Huntsville, Alabama

Meeting Type: City Council Regular Meeting **Meeting Date:** 10/27/2022

Resolution authorizing the Mayor to enter into a contract between the City of Huntsville and the low bidder, Lambert Contracting, L.L.C., for Governors Drive Median Landscaping & Pedestrian Improvements (Mill Creek Action Activity), Base Bid and Option #1, Project No. 71-22-SP27.

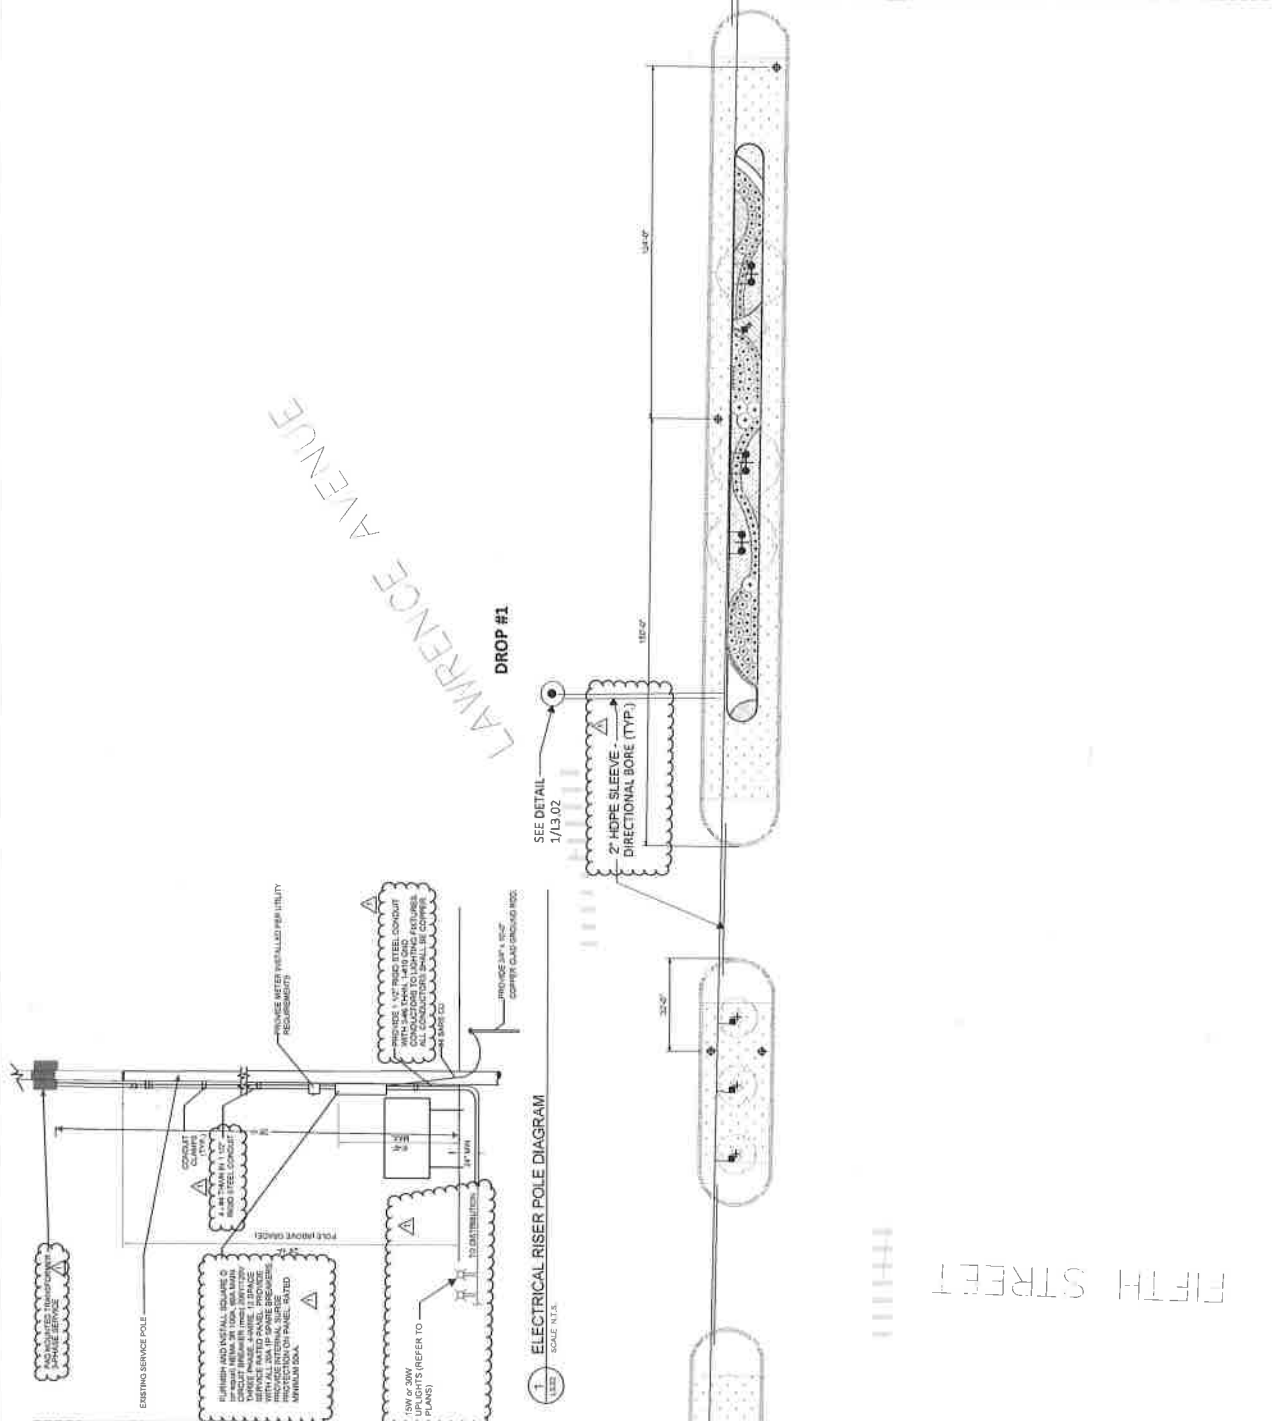
Q: On L3.02 riser diagram shows Provide Meter Installed Per Utility Requirements. Does this mean Meter Base and Meter supplied by Huntsville Utilities as usual?

Q: On L3.02 it shows 1" sch 40 PVC Sleeve Directional Bore. I'm assuming with that size the conduit for the lighting would have to be 3/4". Is this correct?

Q: On sheet L3.02 the Electrical Riser Pole Diagram shows a Pad mount transformer. Is this for the contractor to furnish or the city? If the contractor, do you have any specs on what is needed?

A: Sheet L3.02 has been revised and the transformer is not pole mounted.
